# UNITED STATES PATENT AND TRADEMARK OFFICE

APPLICATION NO.	FILING DATE	FIRST NAMED INVENTOR	ATTORNEY DOCKET NO.	CONFIRMATION NO.
10/562,223	12/23/2005	Ulrich Berens	000611-001	5313
44912	7590	03/25/2008		
WRB-IP, LLP 1217 KING STREET ALEXANDRIA, VA 22314			EXAMINER BOZADJIAN, GEORGE D	
			ART UNIT 1792	PAPER NUMBER
			MAIL DATE 03/25/2008	DELIVERY MODE PAPER

### Office Action Summary

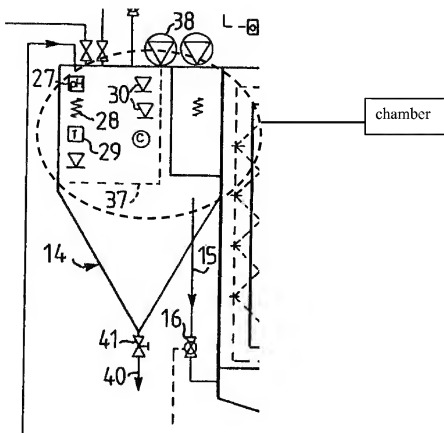
'314 teaches a device (Fig. 1) for purification of machine parts contaminated by oil and grease [Title; Abstract; Figs. 1-2; page 5, lines 21-24], comprising:

a purification housing (1) which can be locked with a lid (2 is a lid that opens and closes so as to seal the washing chamber. For a lid to stay closed and seal a machine that has movable parts, the lid has to be obviously locked), in which a support member (1 and 3 provide a system to hold objects) for receiving the a fluid provided in the housing acts upon the parts to be purified

which are provided on the support (the nozzle system sprays liquid in 1 upon the parts) and a bioreactor (14) for treating the purifying fluid (14 treats the composition of the purifying liquid), where the purifying fluid is provided in a closed circuit via a discharge line (10, 17 and 18) and a supply line (15) between the purification housing and the bioreactor [Abstract; page 5, line 21 – page 6, line 24; page 7, lines 1-25],

a valve (18 is located between the blowing system and the purification housing), which valve is opened for the purifying fluid only at the temperature level of the bioreactor [Fig. 1; page 9, lines 1-8].

9. Claim 6: '314 teaches in an upper area of the bioreactor a chamber (see figure below) is located in order to receive the treated purifying liquid [Fig 1 shows supply line 15 directed from the top, i.e. upper chamber, of the bioreactor to device 1].
